# Access Compliance Report

## Public Rights-of-Way

### (Curb Ramps)

Intersection ID: 44490	Main Street: CHALKSTONE_RD	Cross Street: DARWICK_ST	Location: SE
ADA ID: 79DFEFB1EF03	Ramp Type: Perp	Initial Pass/Fail: Fail	Overall Compliance: No
Severity Score: 21.25			
Codes/Mitigation Info/Possible Solution		Field Measurements/Component Compliance

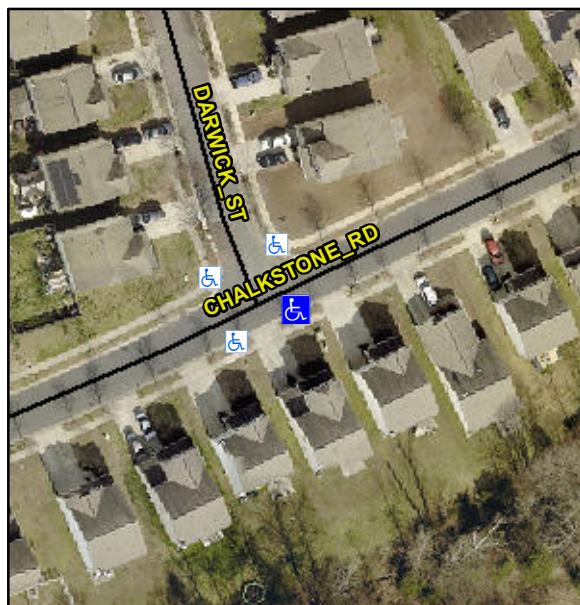
**Not Found, R304.5.1, R304.2.2**

Compliance	Description	Data	Compliance	Description	Data
N/A	Ramp Length (in)	49.0	No	Ramp Slope (%)	9.4
No	Ramp Width (in)	47.0	Yes	Ramp XSlope (%)	1.2
N/A	Flare Type LT	N/A	N/A	Flare Type RT	N/A
N/A	Flare Slope LT (%)	N/A	N/A	Flare Slope RT (%)	N/A
N/A	Flare Traversable LT?	N/A	N/A	Flare Traversable RT?	N/A
N/A	Landing Length (in)	N/A	N/A	DWS Provided?	N/A
N/A	Landing Width (in)	N/A	N/A	DWS Contrast?	N/A
N/A	Landing Slope (%)	N/A	N/A	DWS Length (in)	N/A
N/A	Landing X Slope (%)	N/A	N/A	DWS Full Width?	N/A
N/A	Landing Curb? (Y/N)	N/A	N/A	DWS Offset (in)	N/A
N/A	Shared Landing?	N/A			
N/A	Gutter Ponding?	N/A	N/A	Gutter Slope (%)	N/A
N/A	Gutter Lip Ht (in)	N/A	N/A	Gutter X Slope (%)	N/A
N/A	Painted X Walk1?	No	N/A	Painted X Walk2?	N/A
	X Walk 1 Direction	To N		X Walk 2 Direction	N/A
N/A	X Walk 1 Width (in)	N/A	N/A	X Walk 2 Width (in)	N/A
	X Walk 1 Slope (%)	3.2		X Walk 2 Slope (%)	N/A
	X Walk 1 X Slope (%)	1.0		X Walk 2 X Slope (%)	N/A

**Remove & Replace Entire Ramp.**
